**Fast Track Application – National Green Steel Response on Waikato Regional Council Feedback**

**NATIONAL GREEN STEEL LIMITED'S RESPONSE TO THE QUESTIONS/COMMENTS RAISED BY WAIKATO REGIONAL COUNCIL DATED 28/4/25 and 1/5/25.**

**V2 1/05/2025 (including Air and Ecological Comment) WRC Expert Feedback/Status (V1 28/04/2025)**

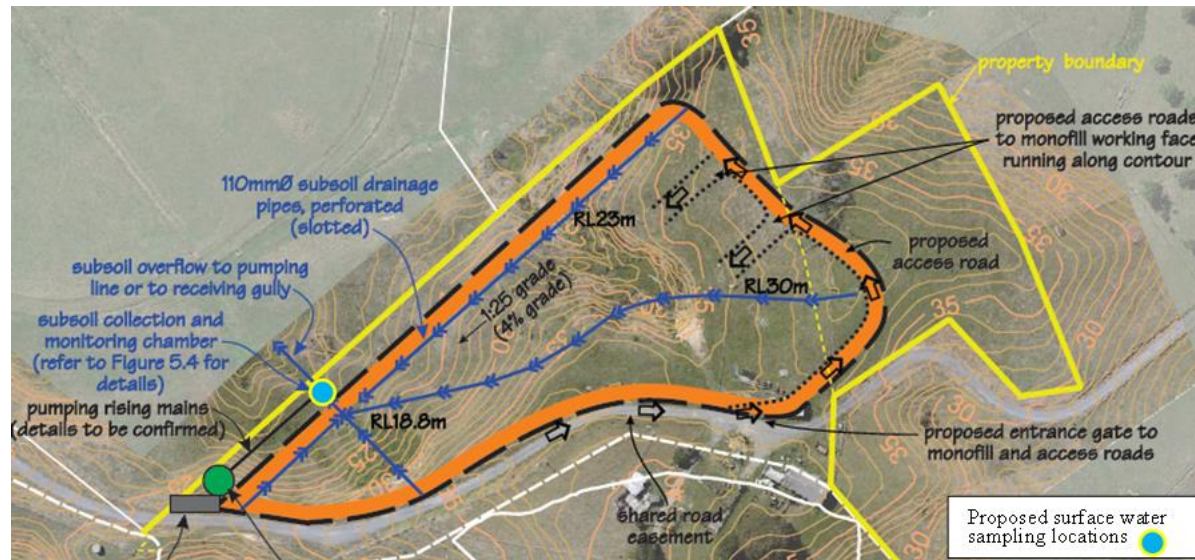
10. In addition to the two sampling locations identified in Figure D in section 5 of the monitoring plan, will there be monitoring of discharges from the Northeastern monofill, the stormwater discharges from the SRP at the northern end of the site and also upstream and downstream of all discharge points so that impacts associated with the site operation can be easily identified and monitored?

Yes, the NE monofill monitoring will mirror the SW monofill. Refer to the Figure below which mirrors Figure D in Section 5.1 in the Monofill Monitoring Report. Monitoring requirements are to be included in consent conditions covering both monofill sites.

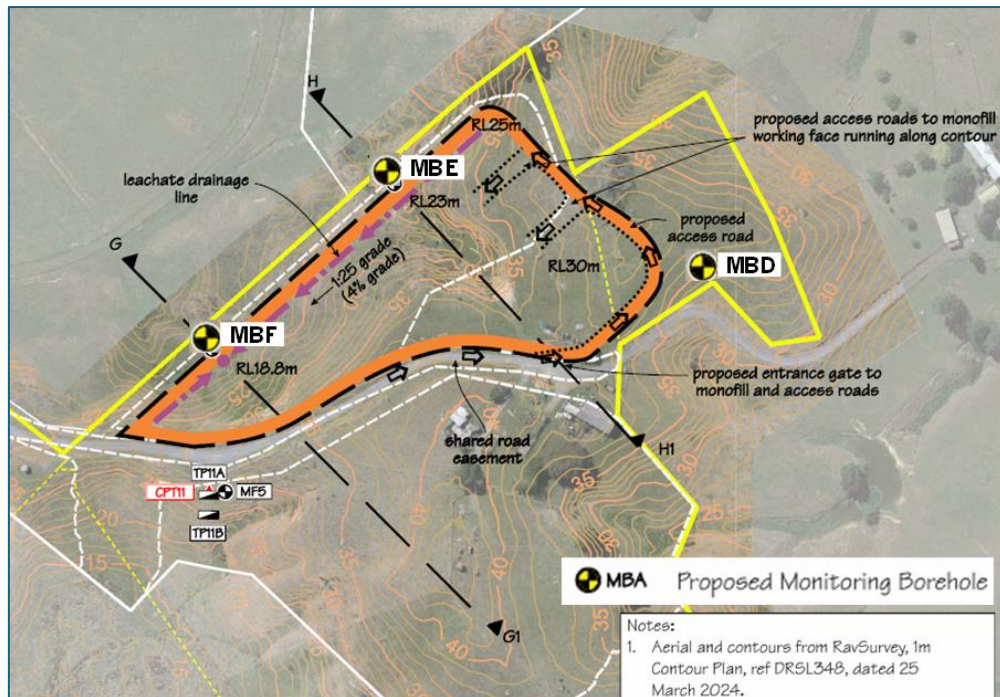
- The proposed locations of groundwater monitoring bores for the SW monofil as indicated on Figure M1.3 are appropriate (MBA, MBB and MBC).

*Noted.*

**Figure 1: Snip from drawing 5577-1-V2 (Ormiston Associates, 13 February 2025) to indicate recommended monitoring bore locations.**

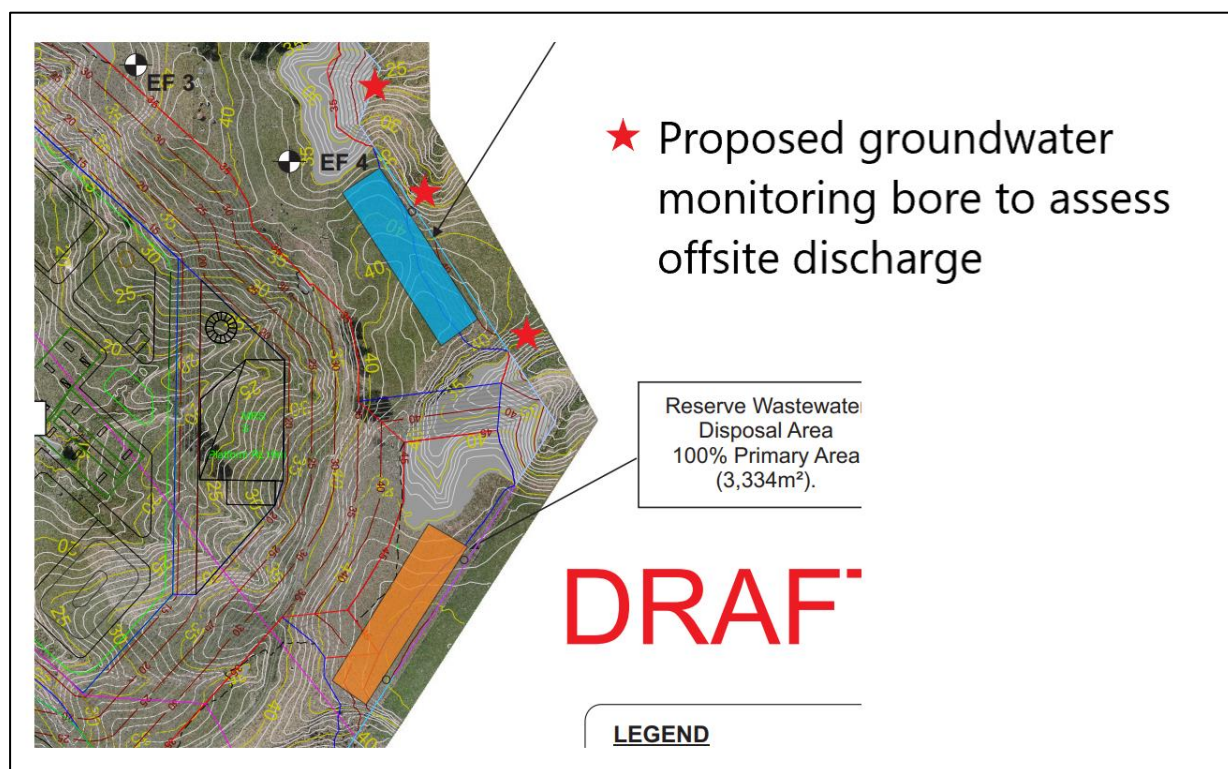
- There is no groundwater monitoring proposed to assess offsite migration of effluent. Due to the topography on site, effluent could potentially migrate northeast from both the primary and reserve wastewater disposal fields towards neighbouring gullies. It is recommended that 3 monitoring wells be established at the site boundary to assess this. I have indicated some proposed locations in Figure 1 below by red stars.

*The request to install groundwater monitoring bores at the site boundary is a higher level of monitoring than would normally be required for a small scale on-site wastewater disposal system, in my experience. For comparison, in terms of the volume of wastewater to be discharged, this proposal represents the equivalent of only 10 dwellings. In my opinion this level of monitoring is not required, as the proposed disposal area loading rates are in line with AS/NZS1547:2012, and the treated wastewater quality will be high (and regularly monitored), hence effects are expected to be very limited. Ms Wilson has indicated the setback distances and Microbial Risk Assessment results are favourable, hence it is unclear why groundwater monitoring is considered necessary. Also there are no nearby groundwater users who would likely be affected. Alternative mitigation measures to address the low likelihood of effects such as planting the disposal area, and construction of a soil bund below any downslope edge may be appropriate alternative approaches.*

Figure 1: Fishing reaches at 61 Hampton Downs Road.

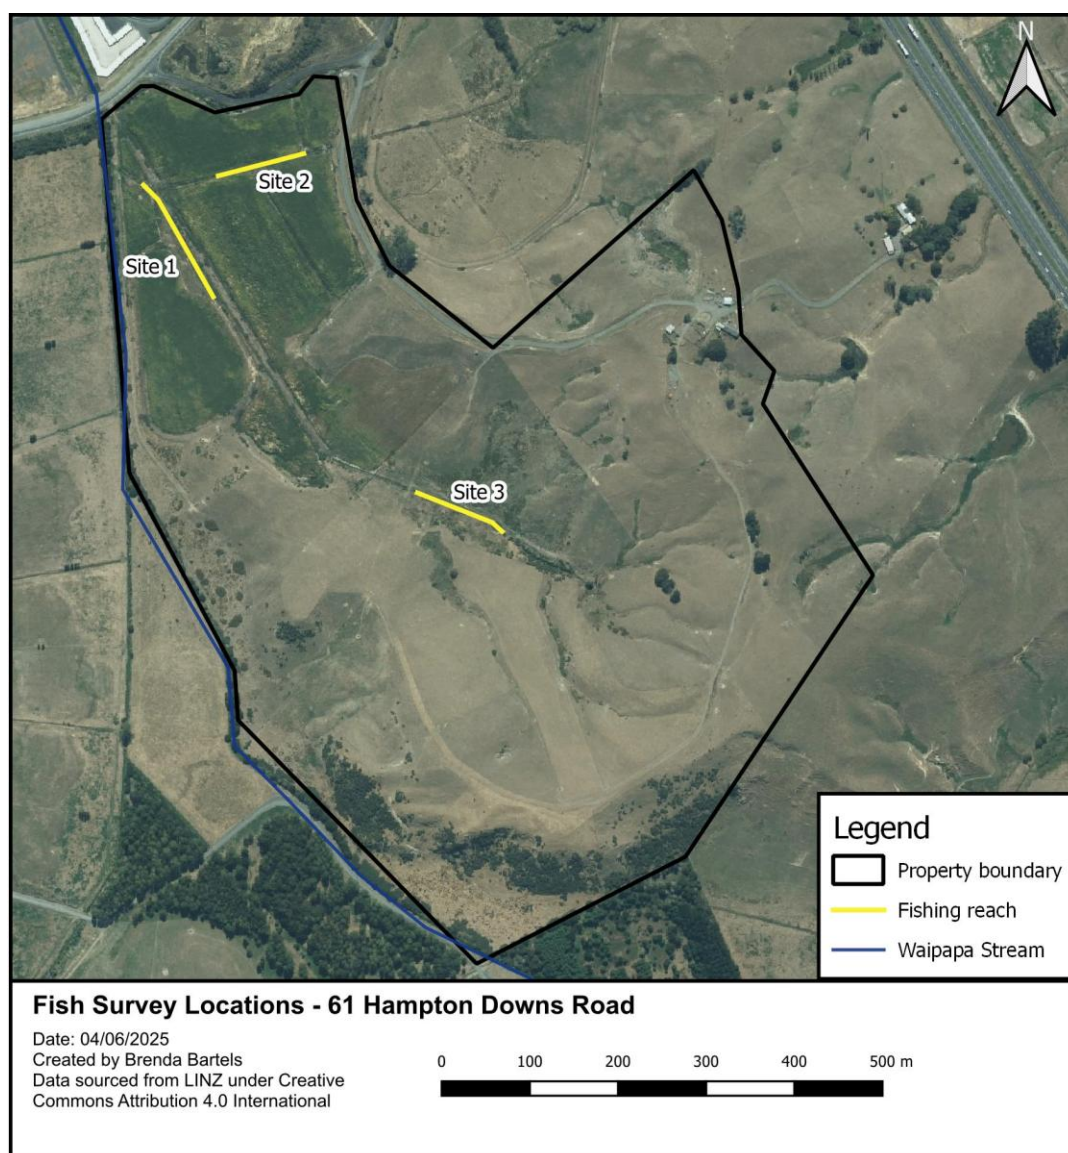
- What locations and what time of year?
  - And who undertook the surveys.
2. Ecological reporting states *"the Waipapa stream sub-catchment has very low water quality and low fish fauna values and is unlikely to still be habitat for black mudfish"* WRC feedback is that sampling would verify the above statement.

A fish survey was undertaken in the main watercourse and targeted mudfish surveys were undertaken in the upper catchment and a side branch of the main watercourse (Figure 1). Nets and traps were set overnight on 3 June 2025. The fish survey in the main watercourse (Site 1) was conducted following standard methodology, which typically involves the deployment of six fyke nets and twelve Gee minnow traps over a 150-metre reach<sup>2</sup>. However, due to limited water depth, fyke nets could only be set in two suitable locations, immediately upstream and downstream of a culvert, where sufficient depth was available.
